**ADDENDUM NO. 1**  
**Sassafras Court Storm Drainage Improvements, Project No. 22484**

IMPROVEMENT PLANS FOR  
**SASSAFRAS COURT**  
**STORM DRAINAGE IMPROVEMENTS**  
**DEMOLITION & TREE PROTECTION PLAN**  
 PLEASANTON CALIFORNIA

PROJECT NO.  
 29225  
 SHT  
**C1.0**  
 OF 8

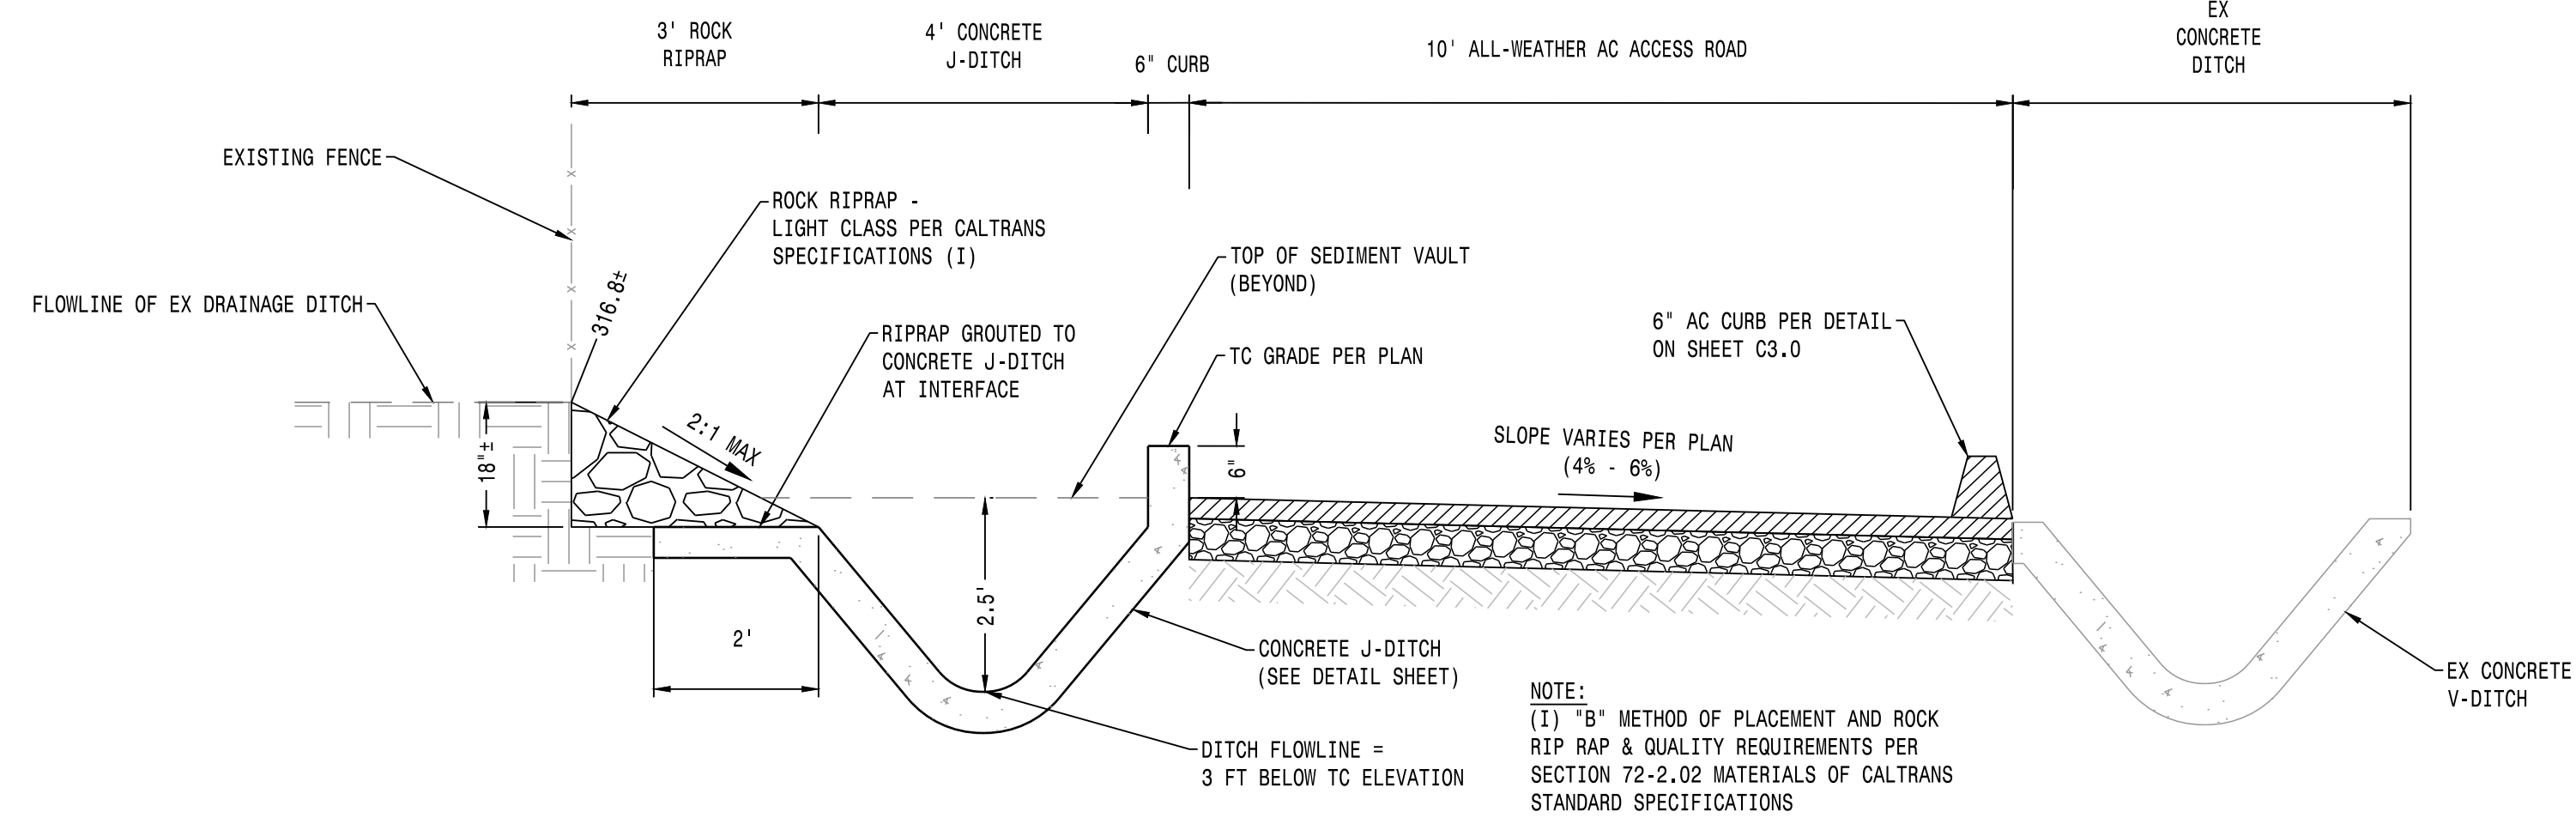
2. Revise the Drawing Sheet C1.0 as follows:

*Add Note:*

**“CONTRACTOR TO PROVIDE TEMPORARY CHAIN LINK FENCING SECURED TO THE EXISTING FENCE TO MAINTAIN RESIDENT'S DOG YARD.”**

Temporary fencing is to be maintained until installation of permanent fencing is complete. This is considered incidental work and no additional payment will be made.

PROJECT NO. 29225  
SHT C2.0 OF 8

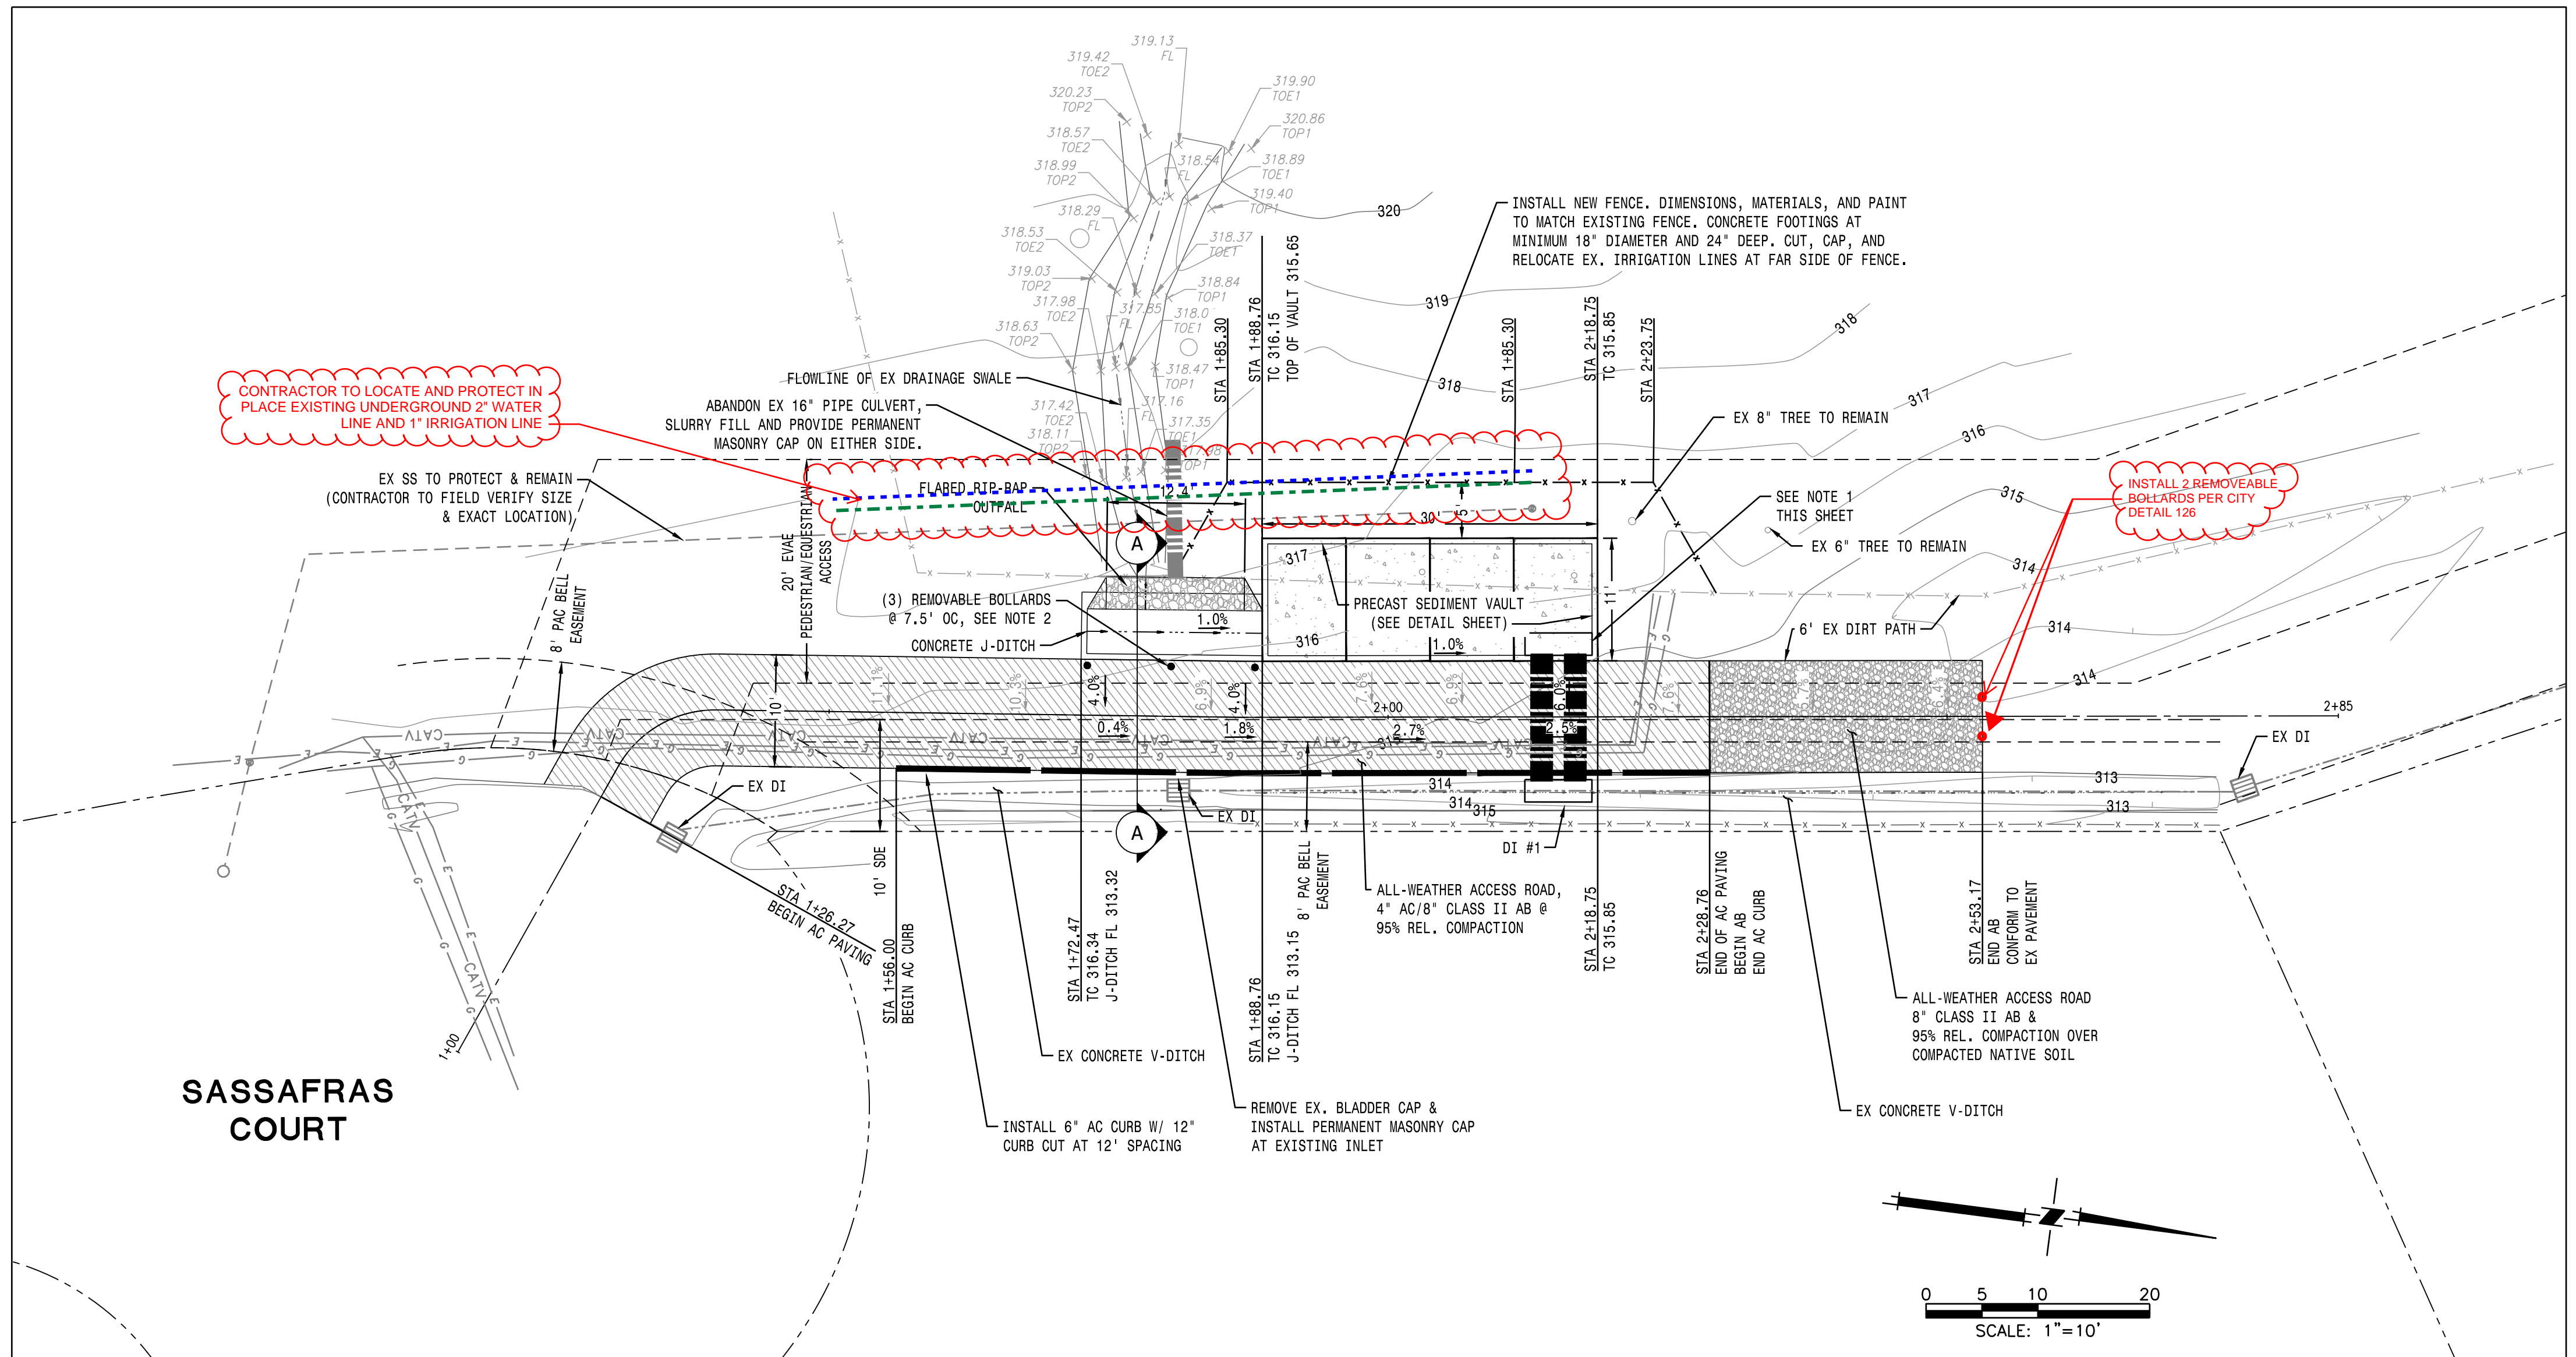
3. Revise the Drawing Sheet C2.0 as follows:

*Add Note:*

**“CONTRACTOR TO LOCATE AND PROTECT IN PLACE EXISTING UNDERGROUND 2" WATER LINE AND 1" IRRIGATION LINE”**

These two lines are parallel and adjacent to the identified sanitary sewer lateral shown on this plan.

4. Revise the Drawing Sheet C2.0 note to the following:  
At Station 2+53.17, The end of the Aggregate Base (AB) All-Weather road centerline, the contractor shall **“INSTALL 2 REMOVEABLE BOLLARDS PER CITY DETAIL 126”**
5. Replace Bid Proposal page 6 with the attached, revised page 6 of the project specifications showing bid item #12 revised to show 5 each removable bollards.

This is considered incidental work and no additional payment will be made.
